# **1996 Annual Prelicensing Inspection of the Mexican Hat, Utah, UMTRA Project Disposal Site**

This report gives the results of the U.S. Department of Energy (DOE) Uranium Mill Tailings Remedial Action (UMTRA) Project annual prelicensing inspection (API) of the Mexican Hat, Utah, disposal site. The purpose of this API is to ensure that the site continues to comply with UMTRA Project design standards.

Attachment 2. Location of Monitor Wells, and See

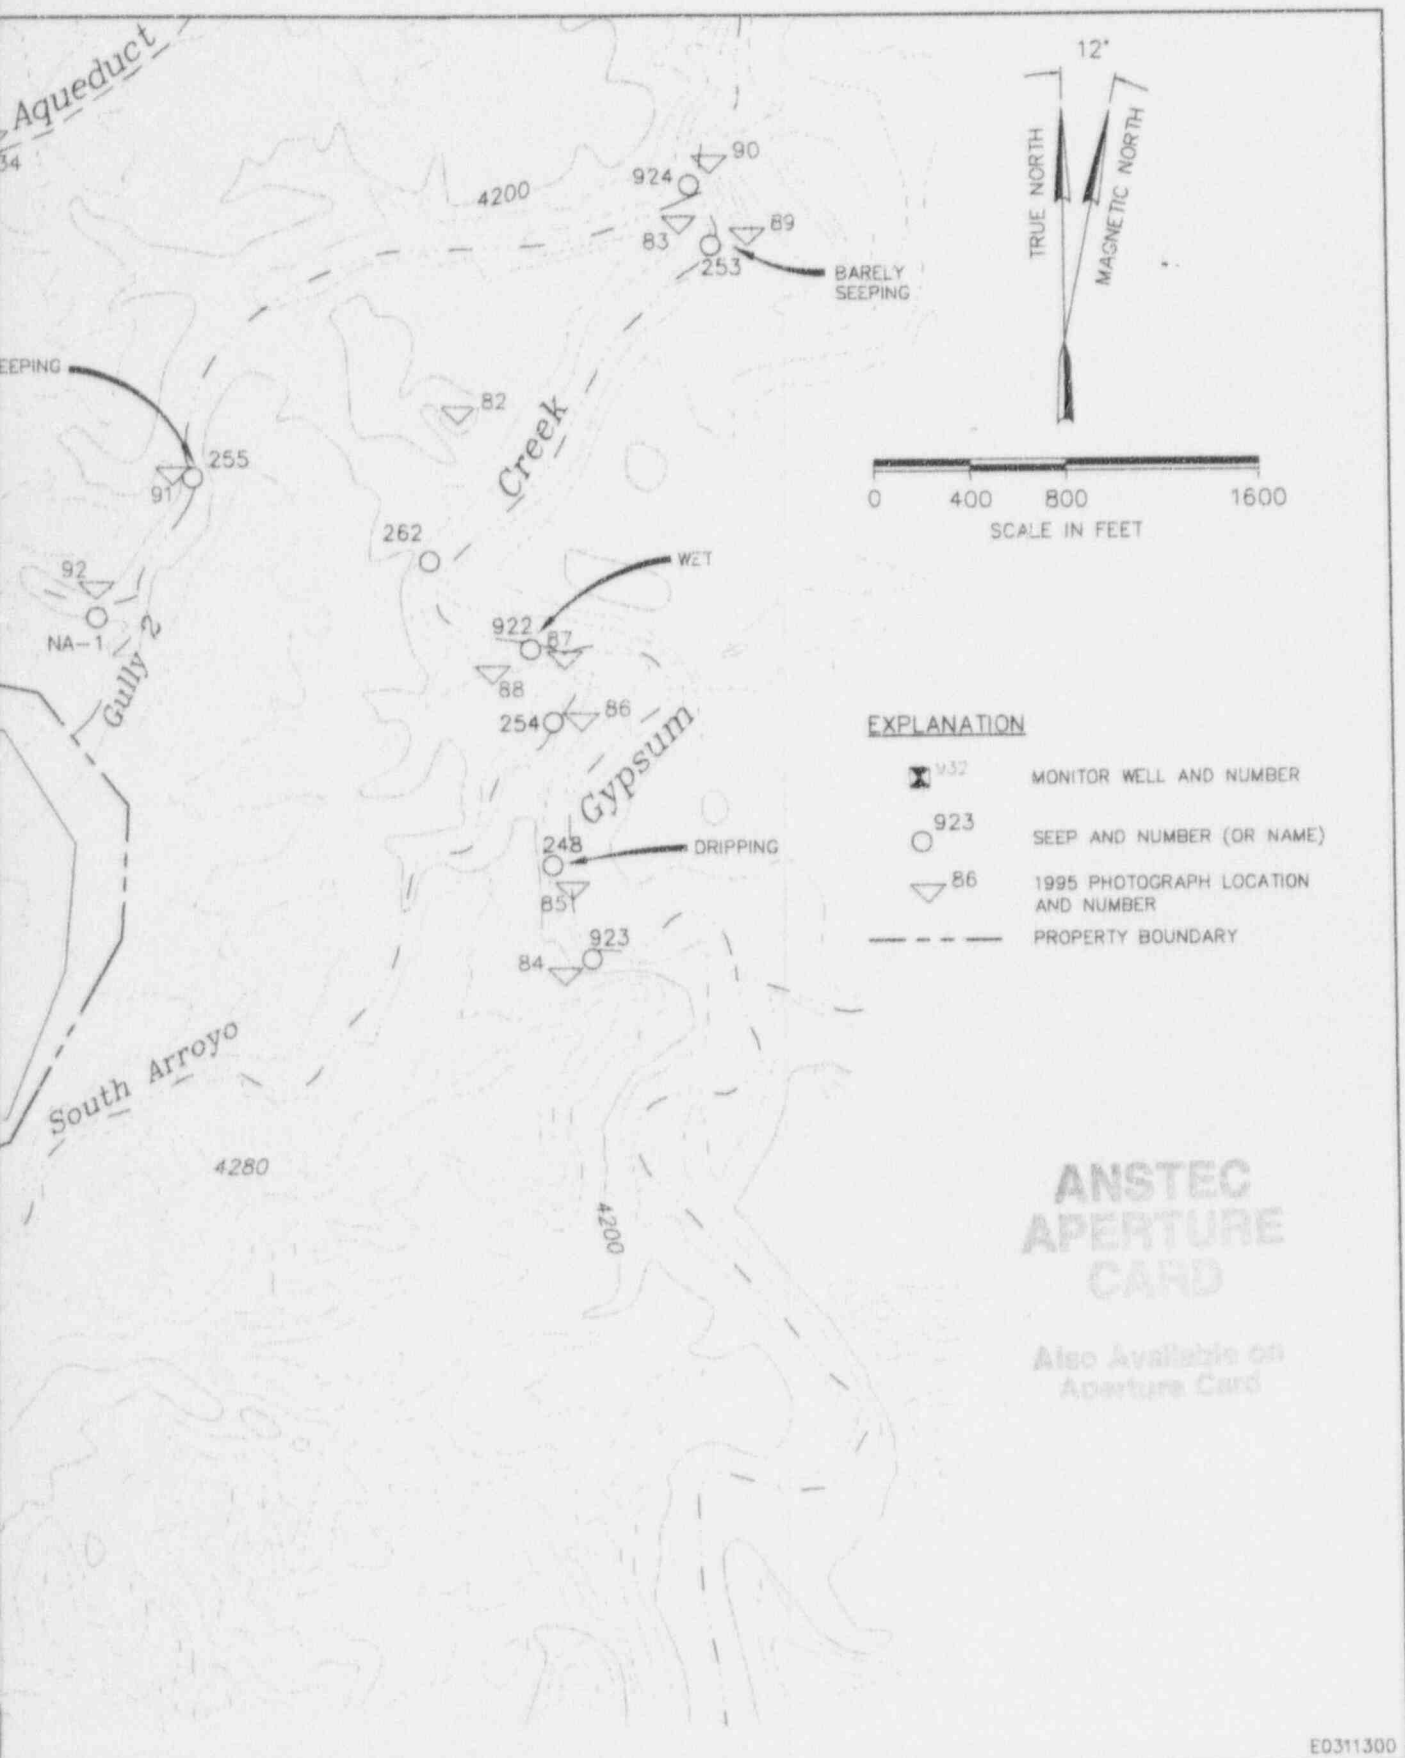
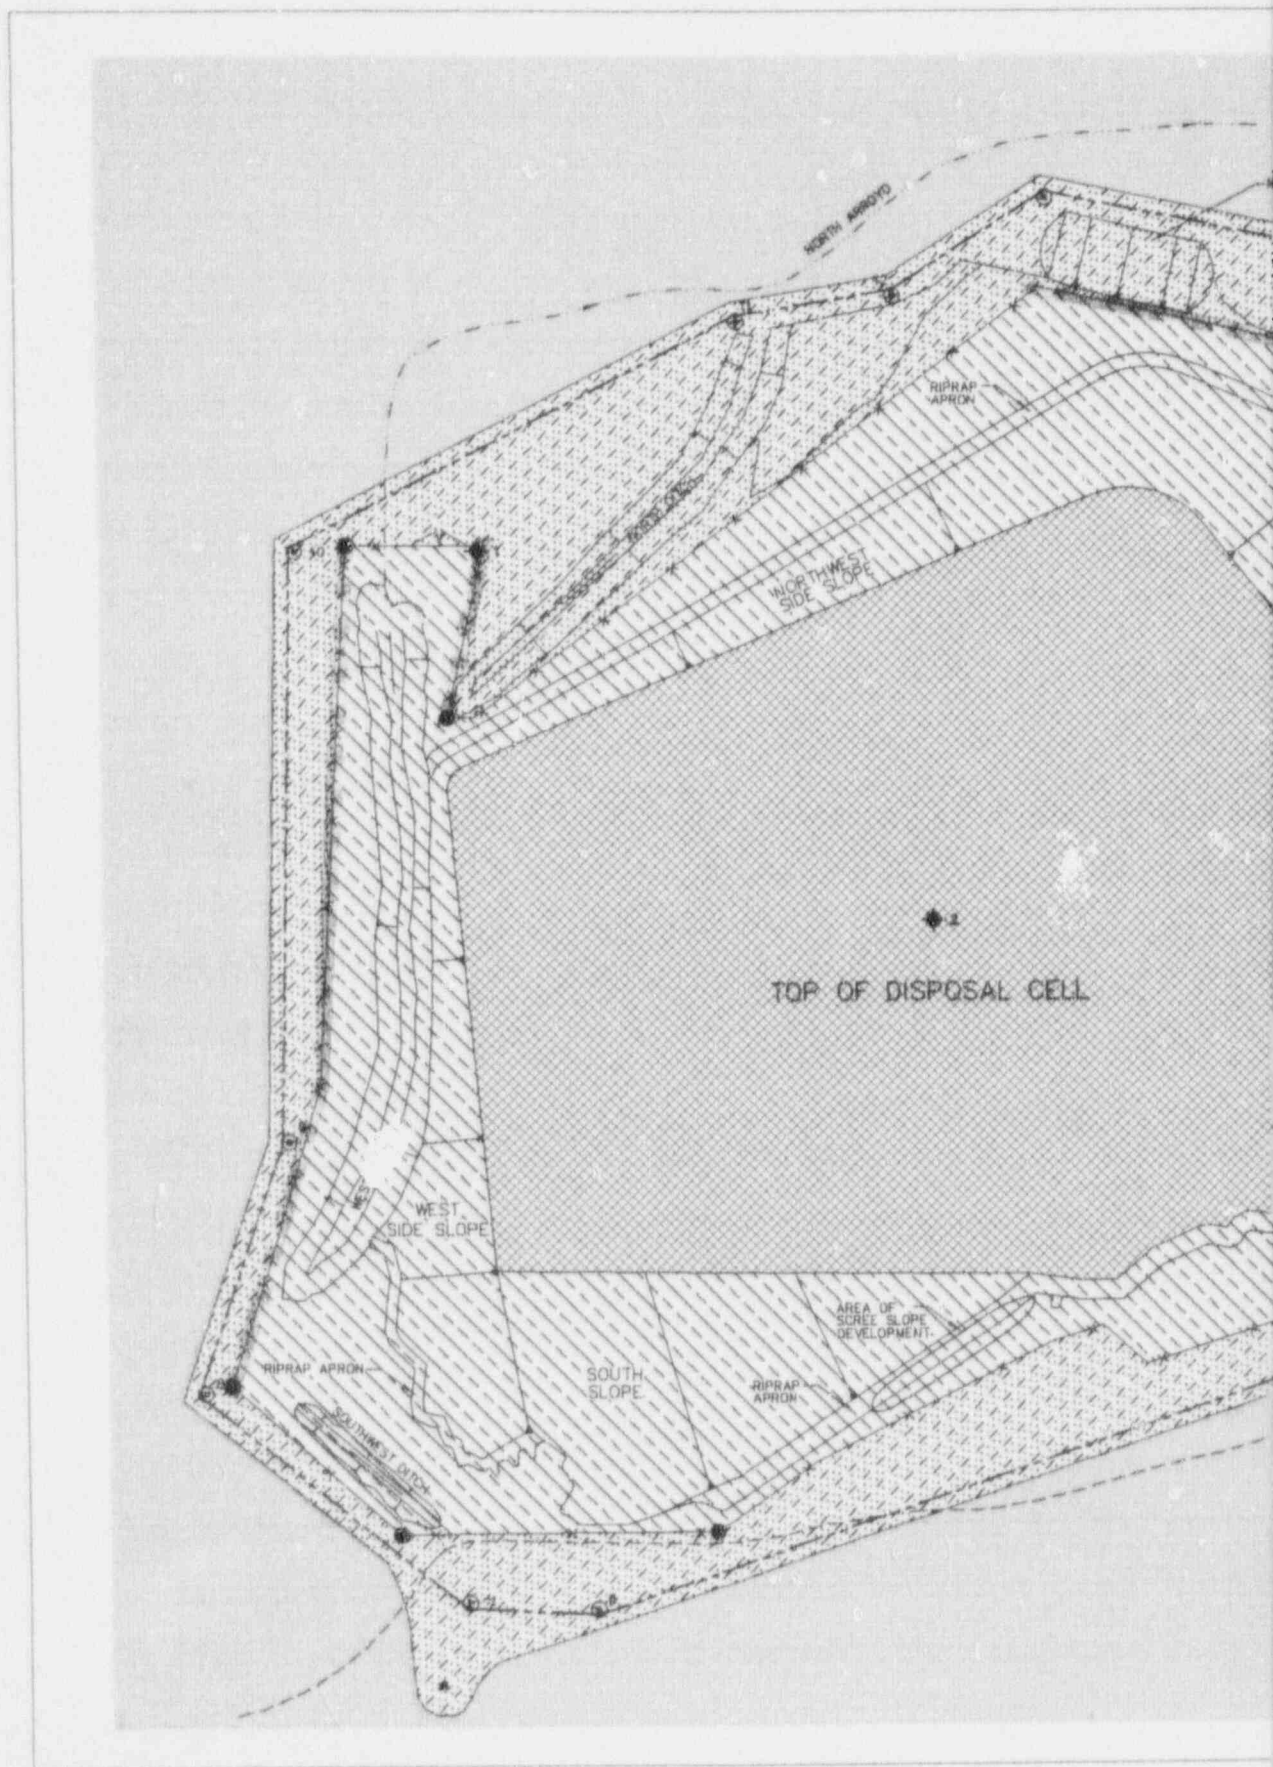
The LTSP states that certain seeps in North Arroyo and along Gypsum Creek will be sampled periodically as a best management practice. The LTSP also states that flow at the seeps may be intermittent. The seeps were inspected to record their current state. Of the several seeps noted in the 1995 inspection report, all but four seeps were dry.

Seep 255 in North Arroyo was damp enough that a sample could probably be obtained if a shallow depression were dug to collect the water. Seep 248, upstream along the west bank of Gypsum Creek, was dripping and could easily be sampled. Seep 922, downstream along Gypsum Creek was wet and could be sampled. Flow from Seep 253, just above the confluence of Gypsum Creek and North Arroyo, was meager but perceptible. The flow was from bedding planes in the rock at about the same elevation as standing water in the creek. A sample here would be difficult because it would be hard to exclude creek water from the sample. Clearly, sampling these seeps will at times be impractical.

The draft LTSP states that these seeps will be sampled "periodically"; but the LTSP gives no indication what an acceptable interval or period might be. It is requested that the UMTRA Project clarify the term "periodically" in the final LTSP, particularly if the DOE has an agreement or understanding with the Navajo Nation or the Nuclear Regulatory Commission (NRC) on the frequency of sampling.

2. The status of six wells, all outside the site boundary, is unknown. Four of the six wells are in disrepair and can not be used for monitoring. These wells are not listed in the LTSP as specific site surveillance features. (See page 2.)

5. The LTSP states that seeps will be sampled periodically, but does not define the term "periodically." (See page 3.)

**Recommendation:** If the Navajo Nation has no use for these wells, the wells should be abandoned. If the UMTRA Project has an agreement or understanding with the Navajo Nations with respect to these wells, this information should be included in the final LTSP before the site is transferred to the GJPO.

**Recommendation:** The UMTRA Project should clarify the term in the final LTSP, particularly if the DOE has an understanding or commitment with the Navajo Nation or NRC on the frequency of sampling.

Attachment 1. Map of Inspection Trans

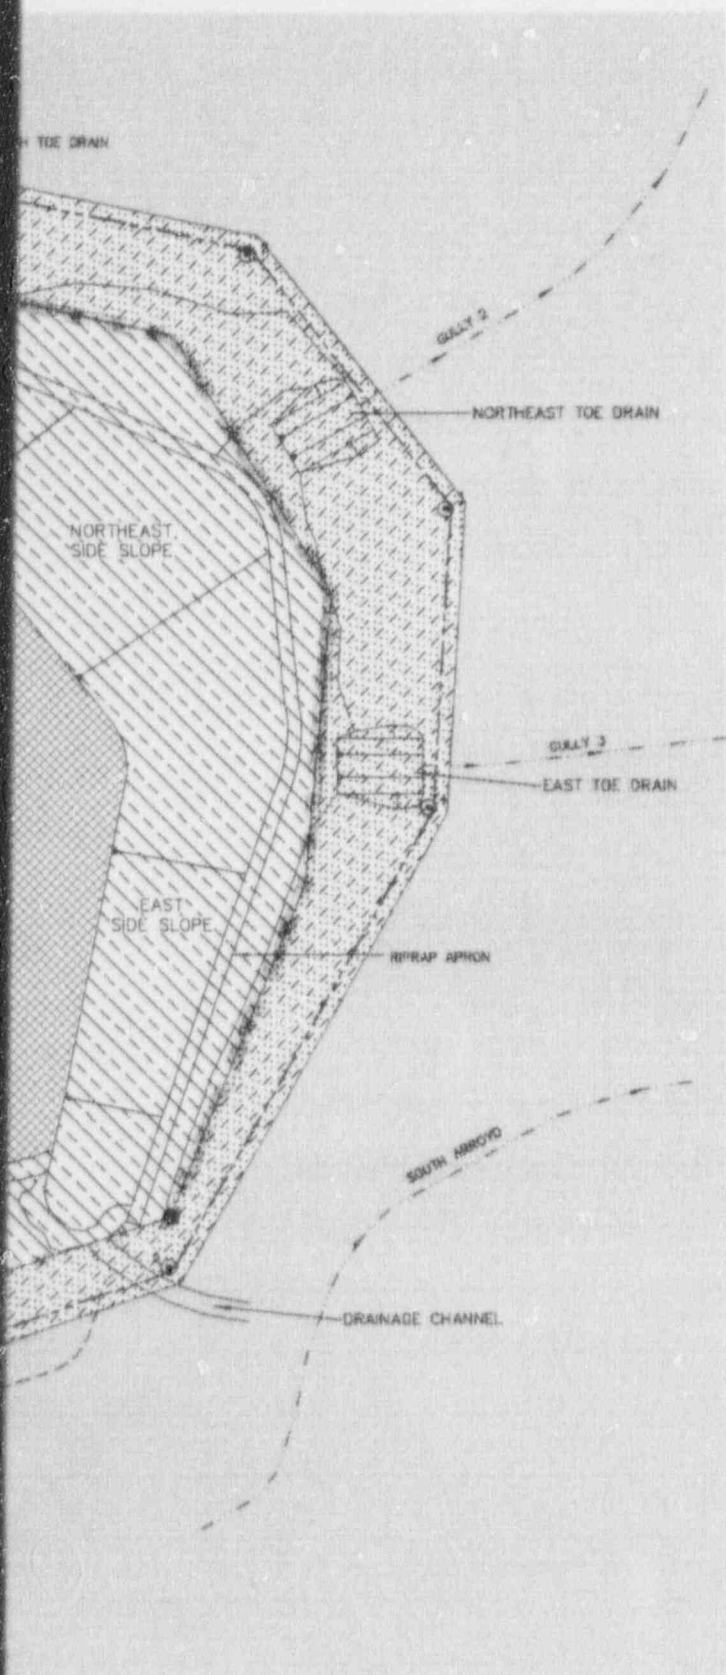
Two problems were noted. First, the bottom strand of barbed wire in the fence, and sometimes the second strand from the bottom as well, are slack at some fence corners. Mr. Charley expressed concern that young livestock could get under and through the fence at these locations. It is recommended the strands be tightened.

Second, here as at other sites in this region, tumbleweeds are beginning to accumulate along fence lines perpendicular to prevailing winds. At this time, the problem can be solved by a few hours of work with a pitch-fork. This work will be easier if completed before this year's crop of tumbleweeds adds to the accumulation.

3. The bottom and sometimes the second strand of barbed wire are slack at several corner posts. (See page 2.)

4. Tumbleweeds are beginning to accumulate along fence lines perpendicular to prevailing winds. (See page 2.)

**Recommendation:** Take up the slack to keep young livestock out.

**Recommendation:** Clear the weeds from the fence line before this year's crop adds to the accumulation.
